APPROVED BY LOGAN CO. ENGINEER

UNITED PRECAST INC.

DESCRIPTION : BOX BEAM DETAILS

BRIDGE NO. C.R. 52-0.02 LOGAN COUNTY ITEM 515

DECK PLAN

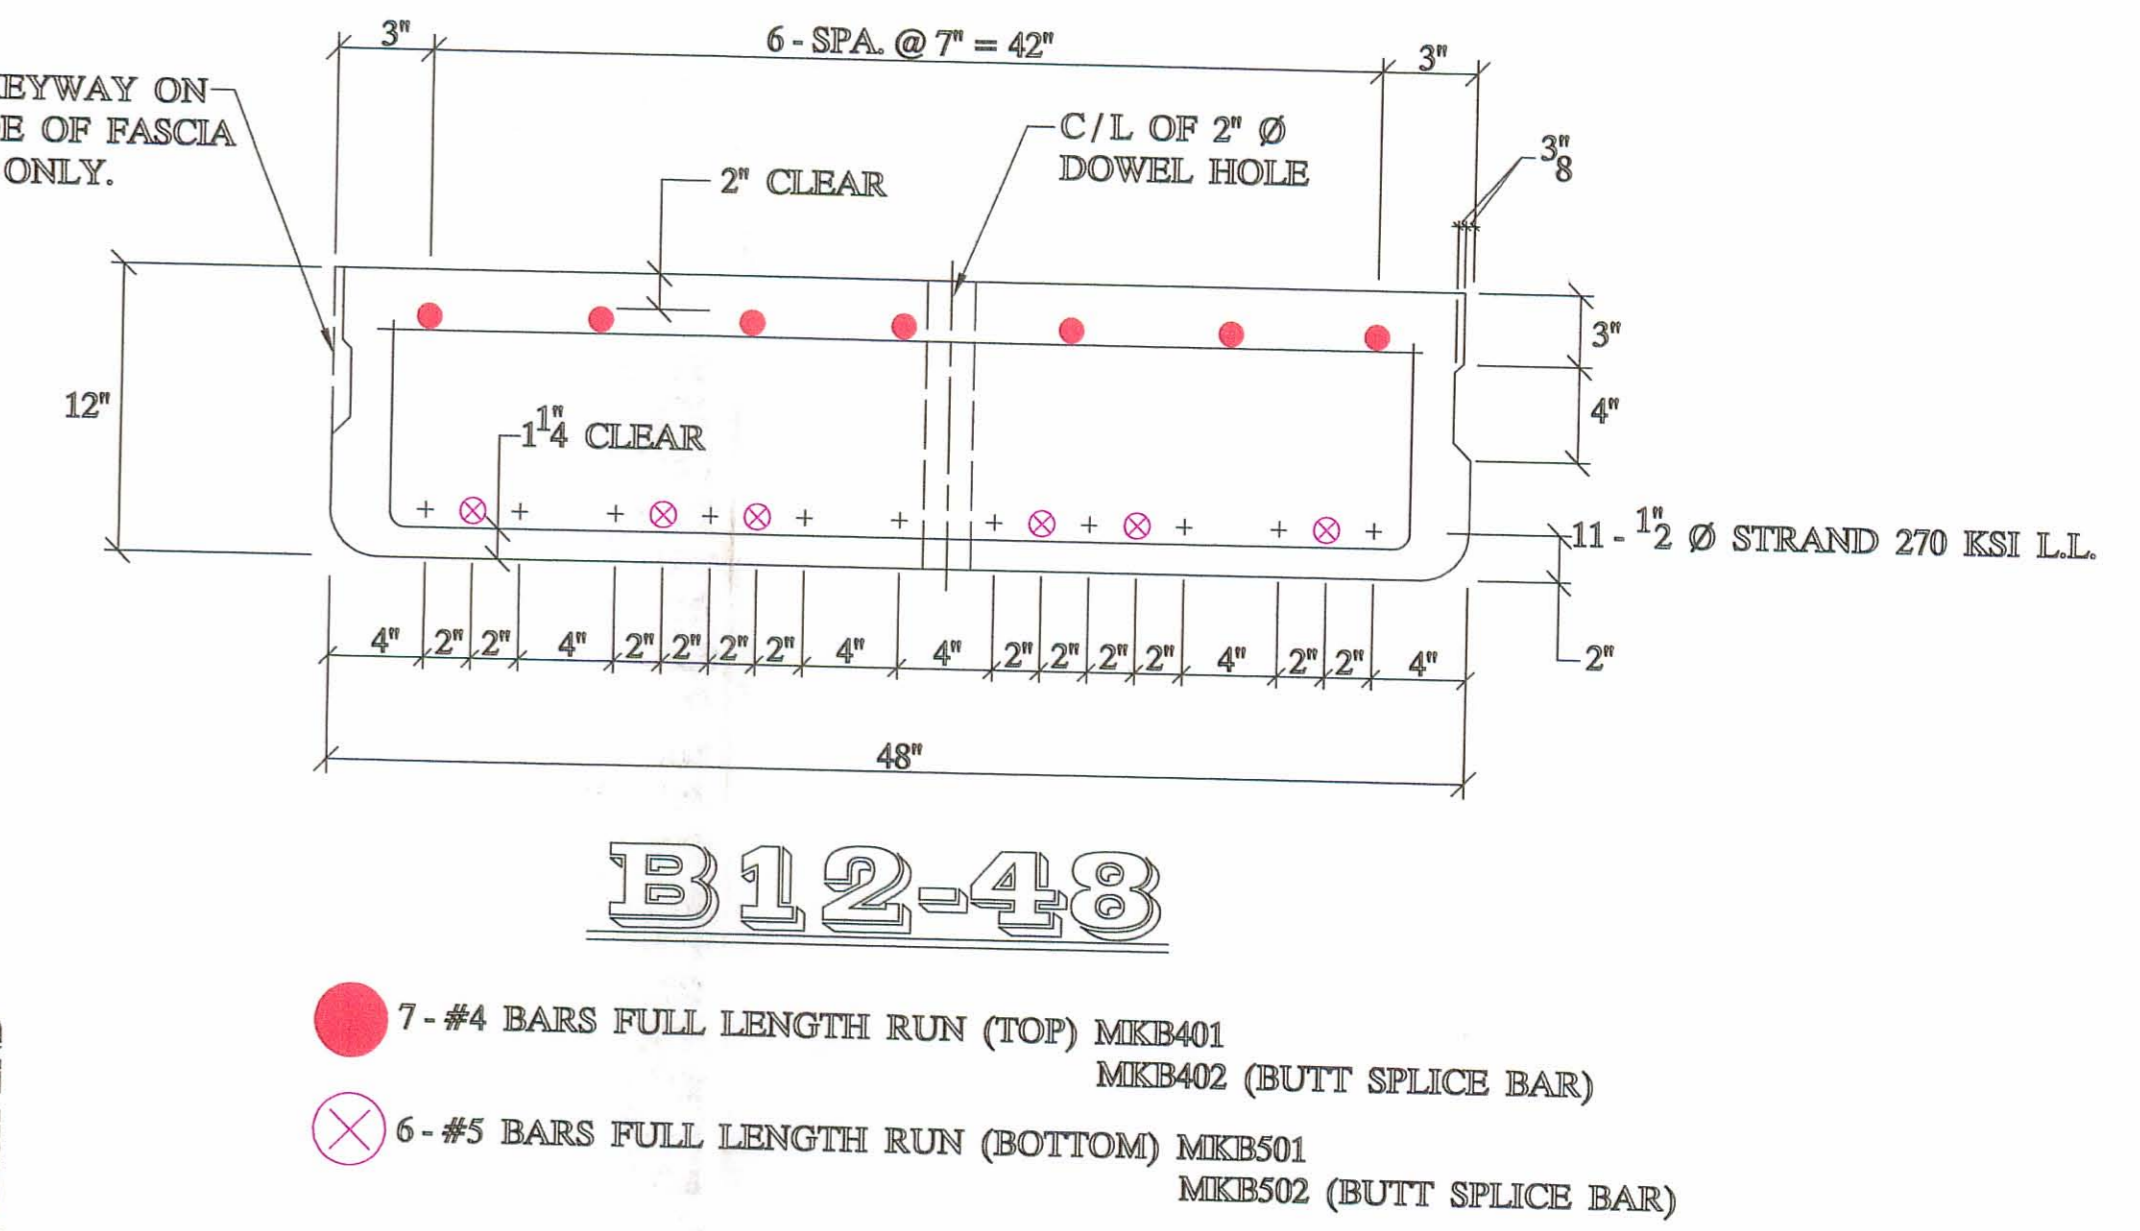
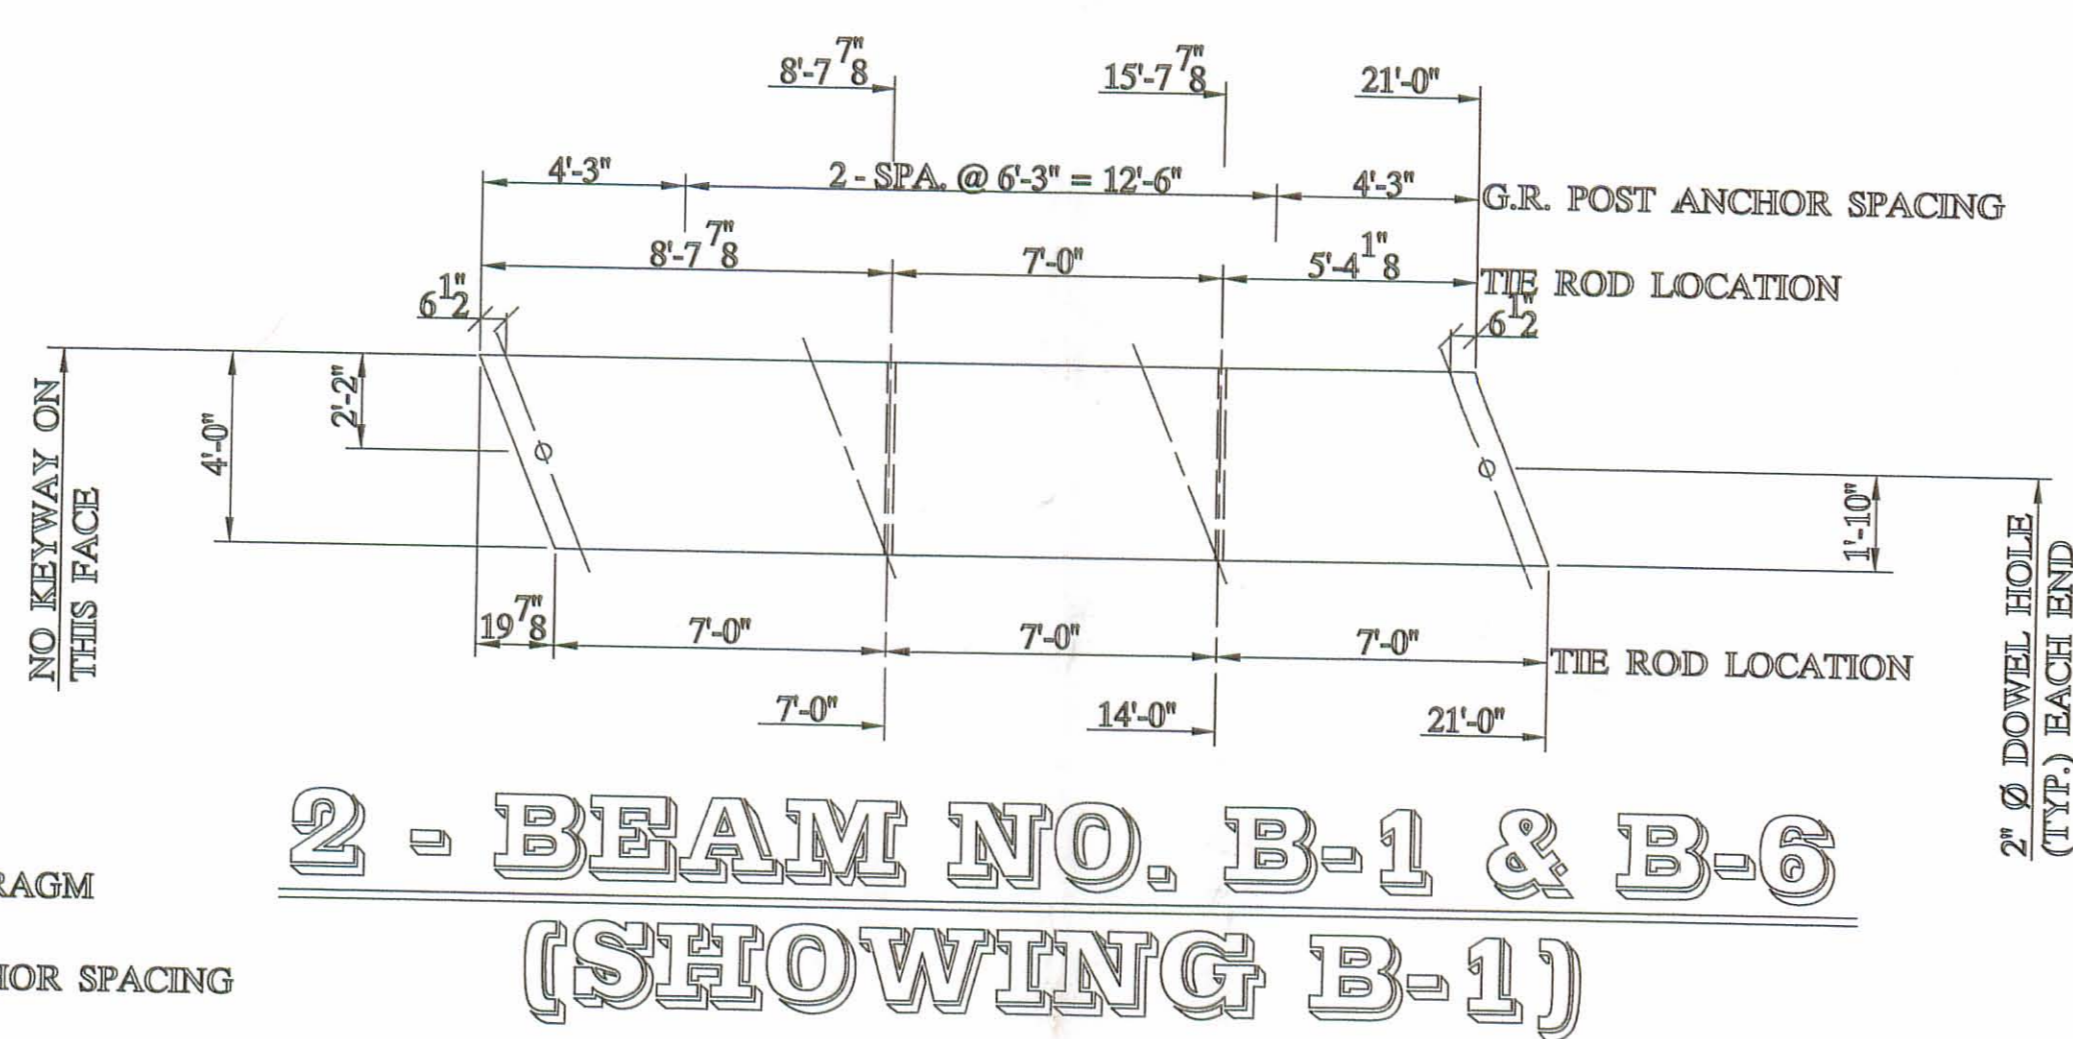
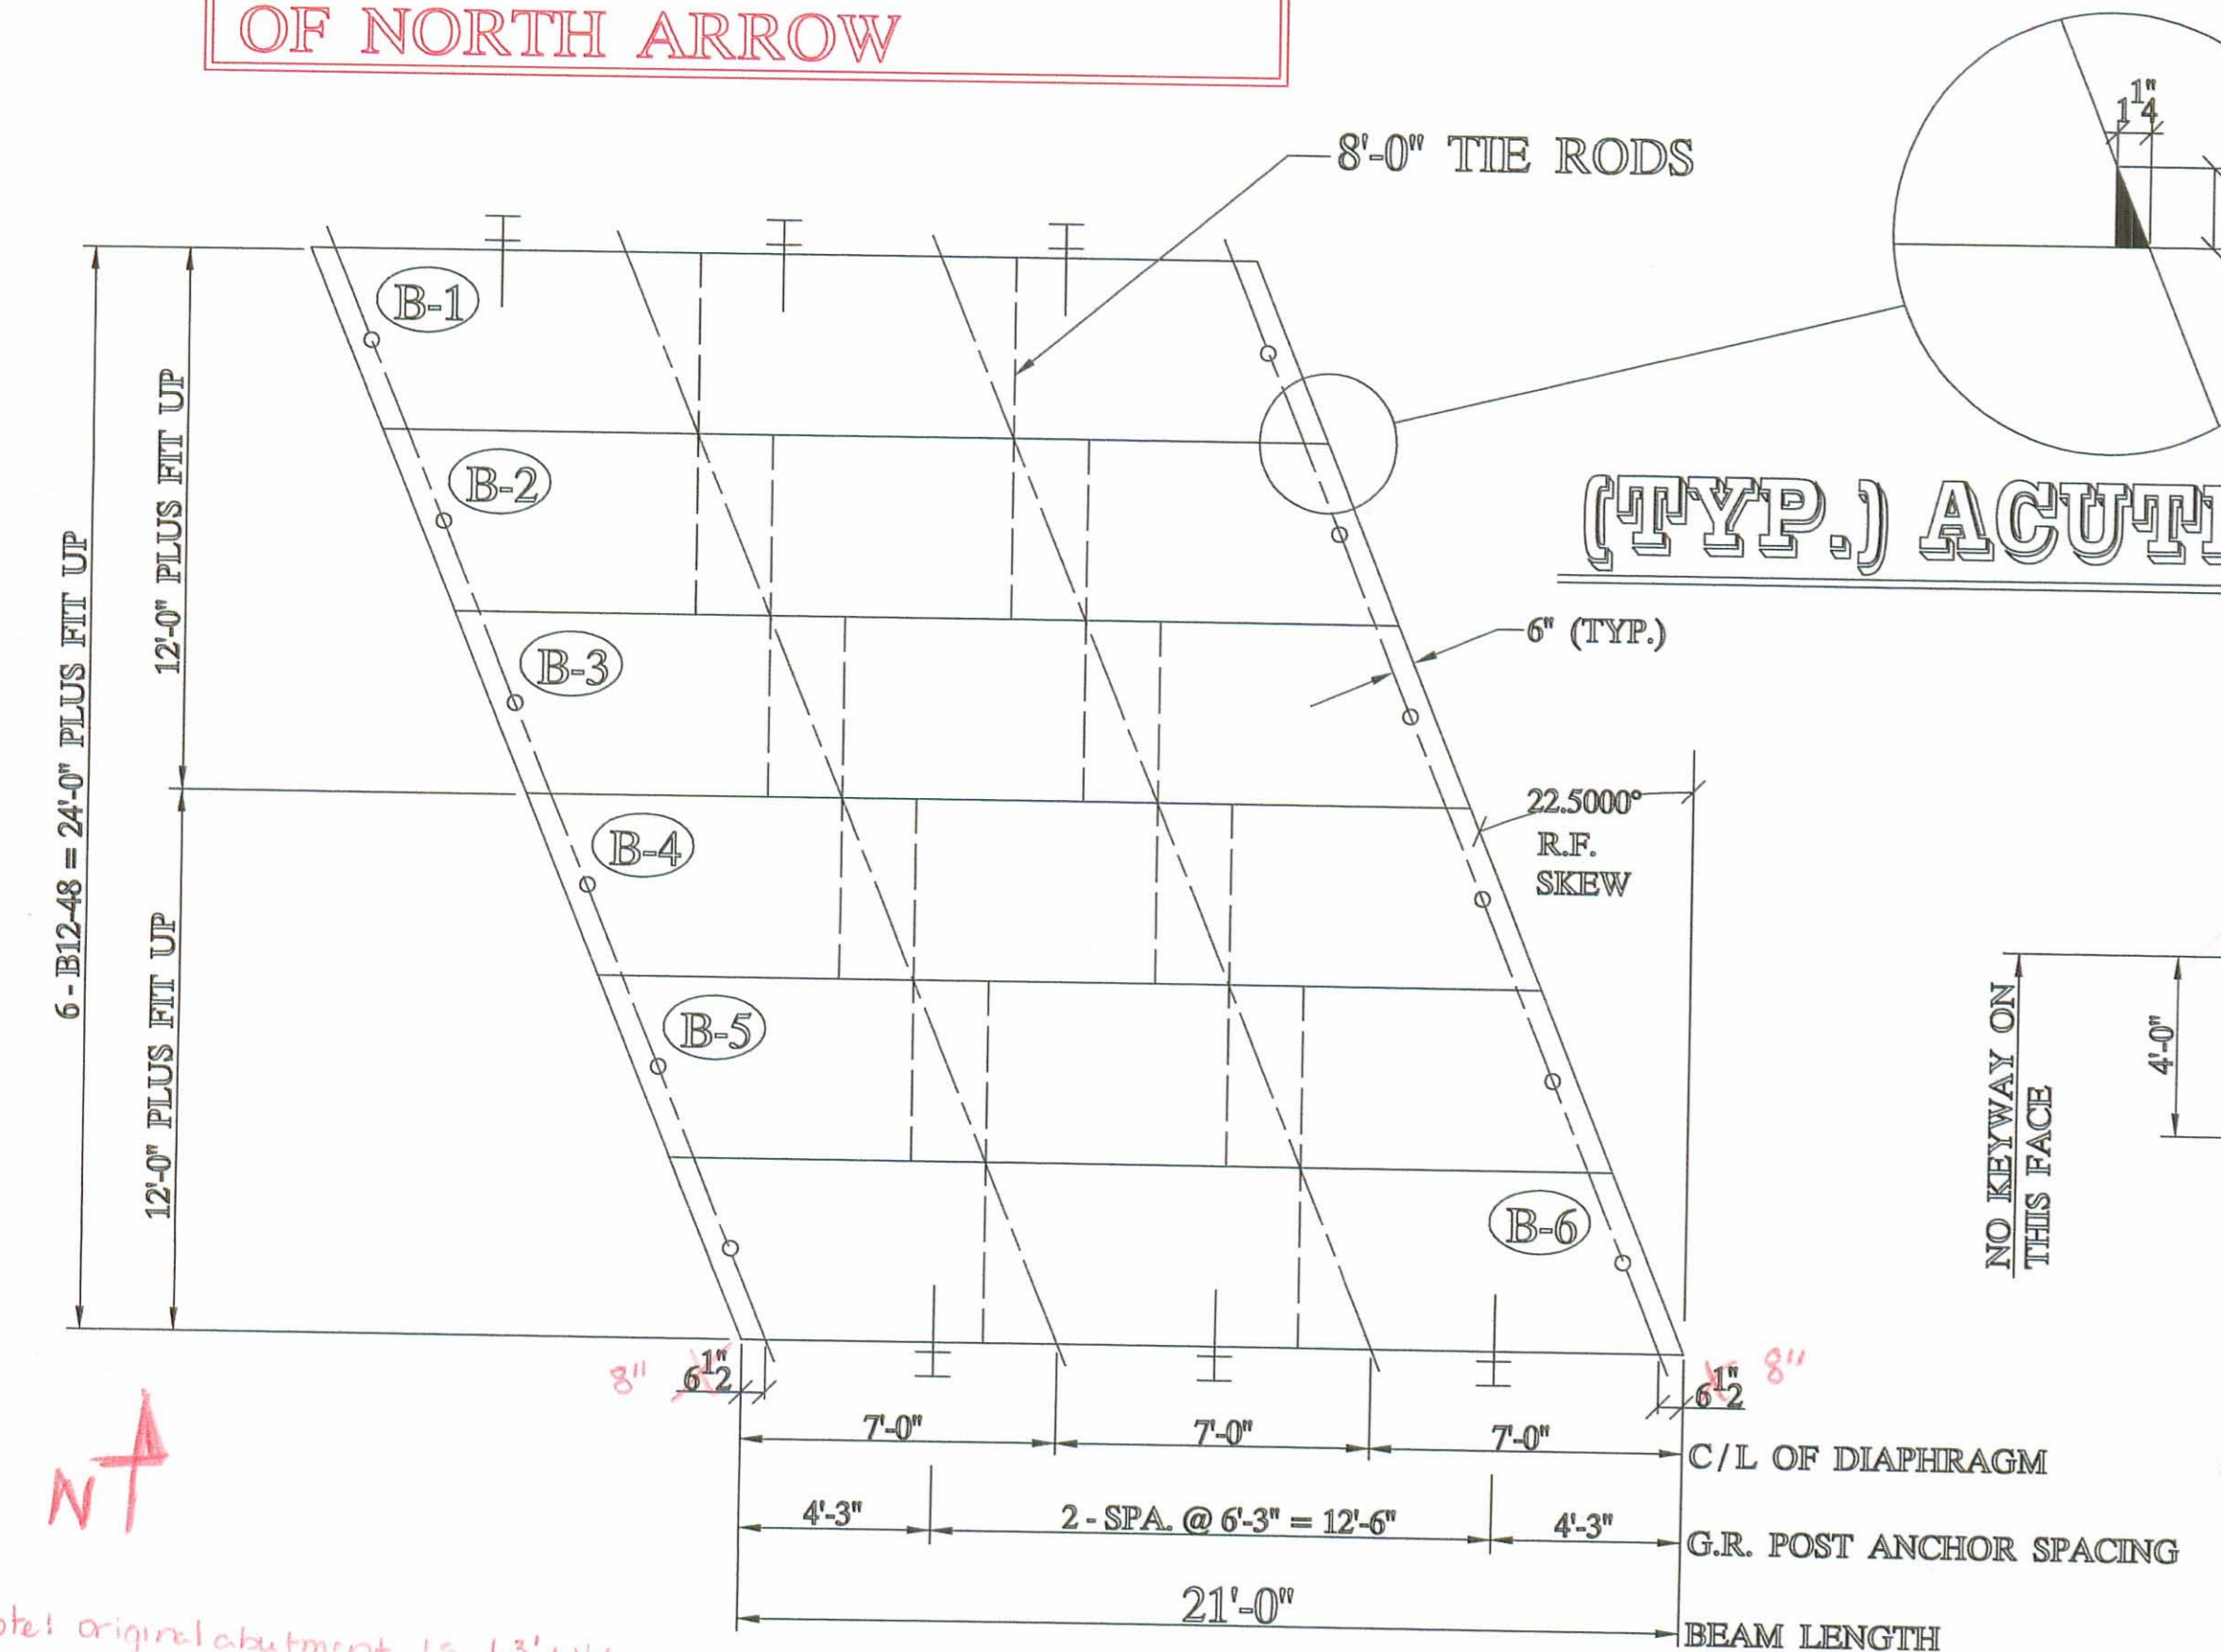
PLEASE INDICATE DIRECTION OF NORTH ARROW

Note: original abutment is 1.3' wide measured to face. We want to center dowels on abutments - extend extra length past the abutment. This change is 8" or 8.5" per your judgment. 18.1' FF is the dimension to road.

SL note on deck plan
